Love Canal Emergency Declaration Area Remediation of EDA 2 and 3 Final Study Report

May 1991

New York State Department of Health

New York State Department of Environmental Conservation

Figure 2. Location of soil core samples collected in EDA 2 on December 4-8, 1989.

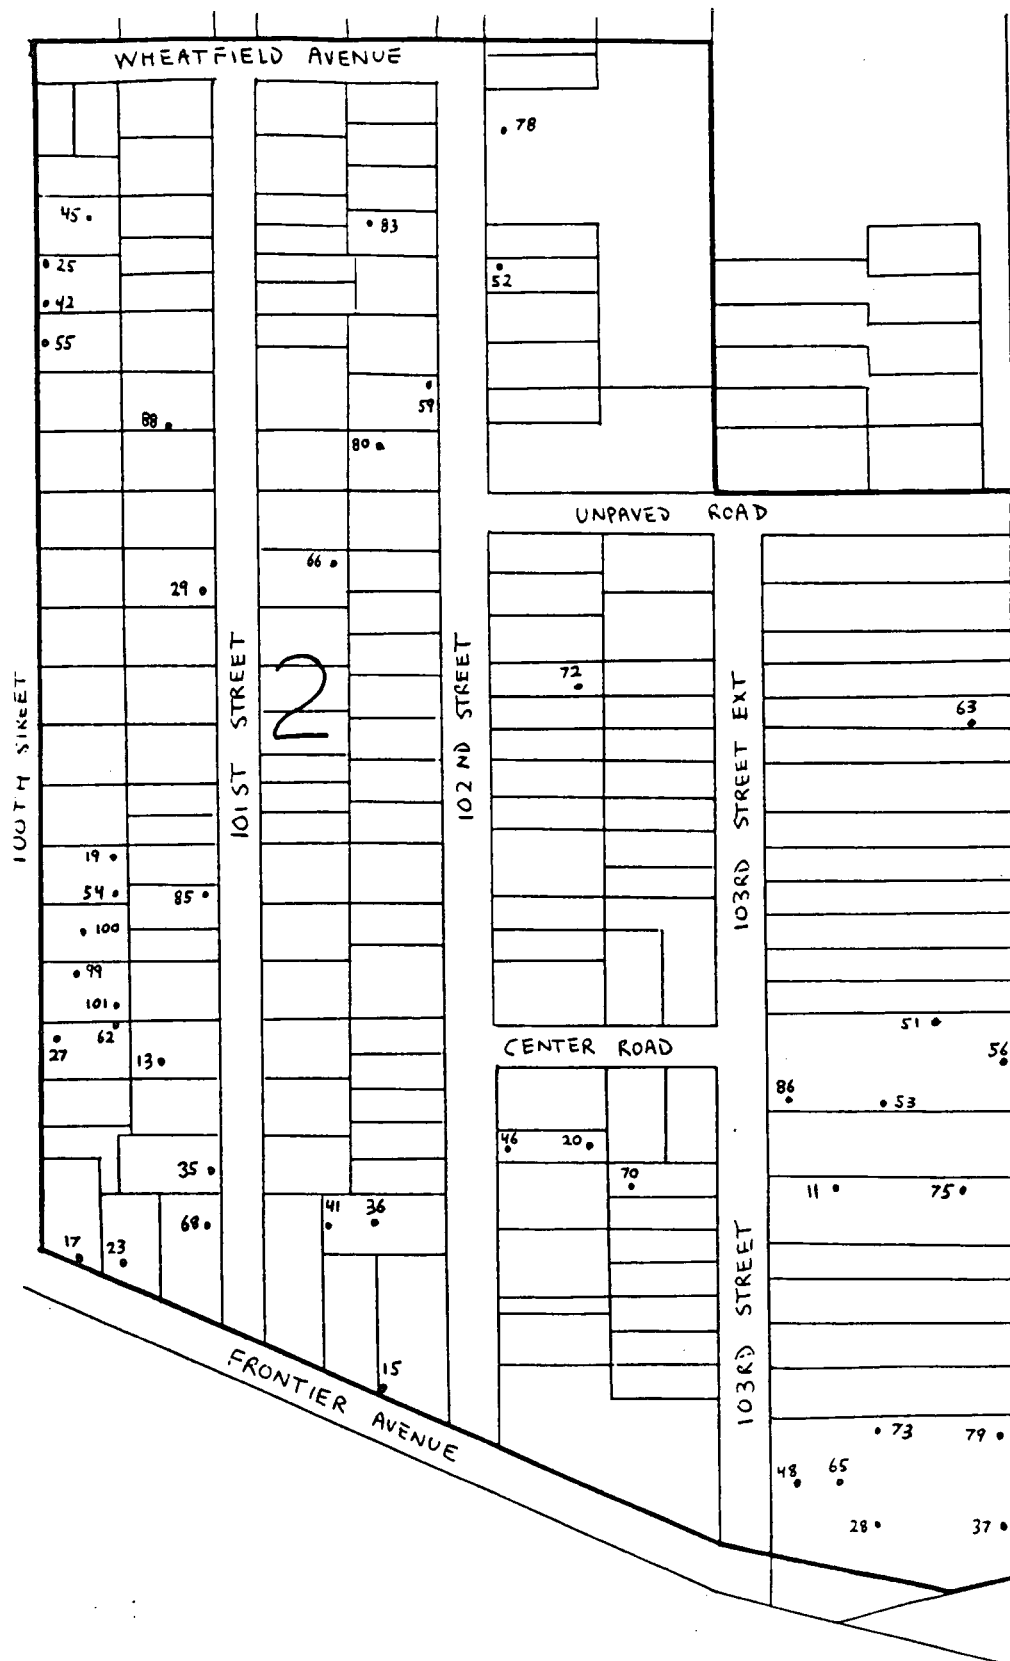
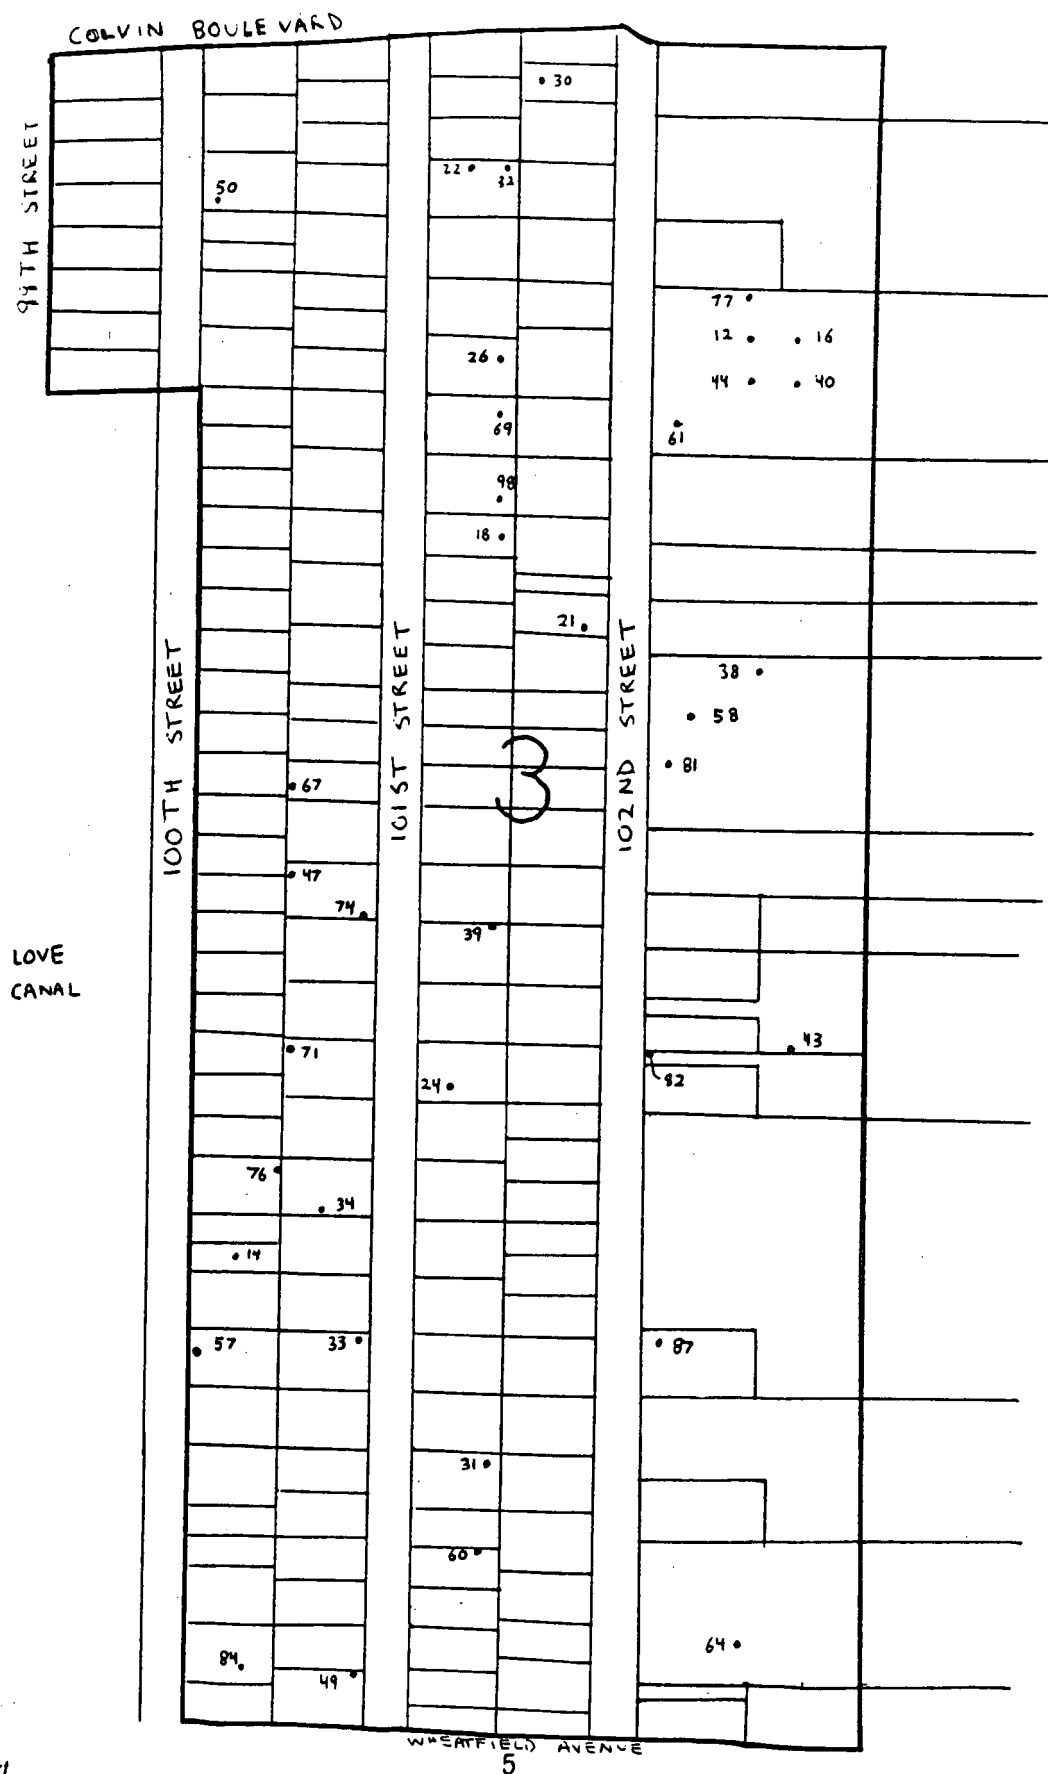
A well-devised sampling plan for the soil samples would include measurements of variables that may be suspected of affecting the degree of contamination: for example, the amount of moisture in the soil; soil type, including organic content;

and vegetation. These measurements would be important to ensure that the statistical analysis is not skewed by other factors that more strongly correlate with the presence of LCICs. However, the sampling plan for the draft study report included no such safeguards.

The draft study report fails to explain -- or even acknowledge -- implications from the data that raise questions about conclusion. A review of Appendix C, "Individual Sample Results," reveals many sampling locations where LCICs are present in the soil from 6 to 12 inches below the surface in amounts as great or greater than at 3 inches. Indeed, we count 17 such locations out of 39 total sampling locations in EDA 3. That is, approximately 44 percent of the sampling locations in EDA 3 show a pattern of contamination inconsistent with the general conclusion of the draft study report that removal of the top six inches of soil will be sufficient remediation.
